**ZONING AMENDMENT,
PLANNED UNIT DEVELOPMENT &
SUBDIVISION STAFF REPORT**

Date: January 6, 2005

<u>NAME</u>	N T G – C Investments
<u>DEVELOPMENT NAME</u>	Westwood Subdivision
<u>LOCATION</u>	2202, 2204, 2206 and 2008 Airport Boulevard (Northeast corner of Airport Boulevard and Westwood Street)
<u>CITY COUNCIL DISTRICT</u>	District 5
<u>PRESENT ZONING</u>	B-1, Buffer-Business and B-2, Neighborhood Business
<u>PROPOSED ZONING</u>	B-2, Neighborhood Business
<u>AREA OF PROPERTY</u>	.8 ± Acres
<u>CONTEMPLATED USE</u>	Parking lot expansion for an existing retail center It should be noted, however, that any use permitted in the proposed district would be allowed at this location if the zoning is changed. Furthermore, the Planning Commission may consider zoning classifications other than that sought by the applicant for this property.
<u>TIME SCHEDULE FOR DEVELOPMENT</u>	Upon approval
<u>ENGINEERING COMMENTS</u>	Must comply with all stormwater and flood control ordinances. Any work performed in the right of way will require a right of way permit.

SITE PLAN

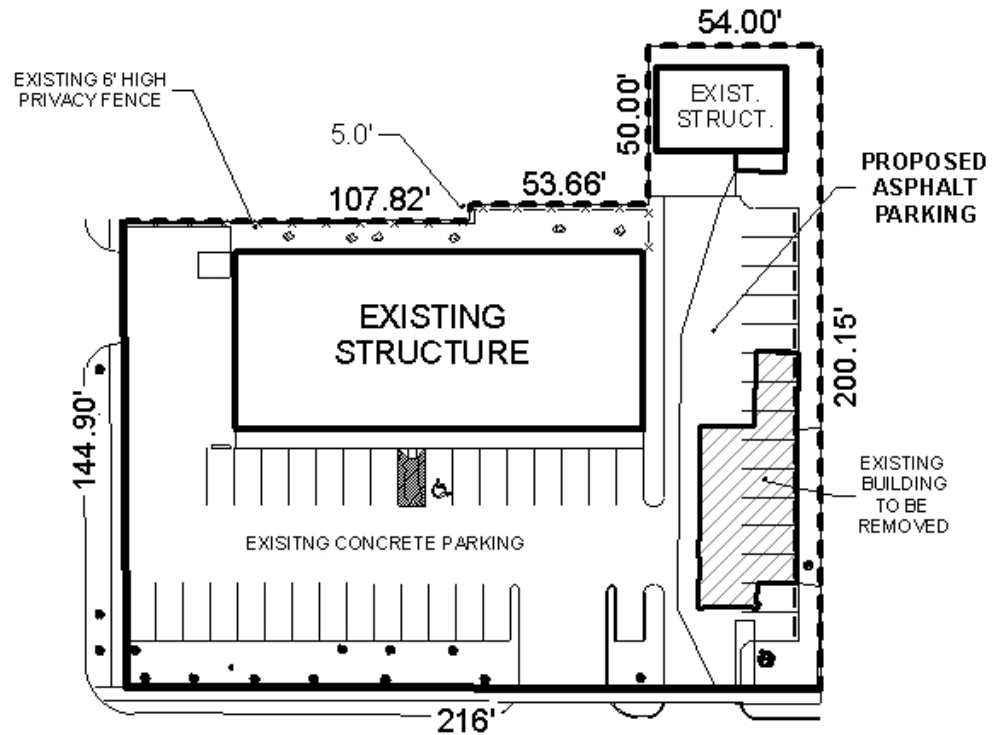
As the site fronts a major street, access management is a concern. The site plan illustrates a second curb cut in front of the new parking area, and this curb cut would be located less than 30-feet from the existing curb cut. The site should be limited to one curb cut, with the location and design to be approved by Traffic Engineering.

Subdivision The plat meets the minimum requirements of the Subdivision Regulations and is recommended for Tentative Approval subject to the following condition: 1) placement of a note on the final plat stating that the site is limited to one curb cut to Airport Boulevard, with the size, location and design to be approved by Traffic Engineering.
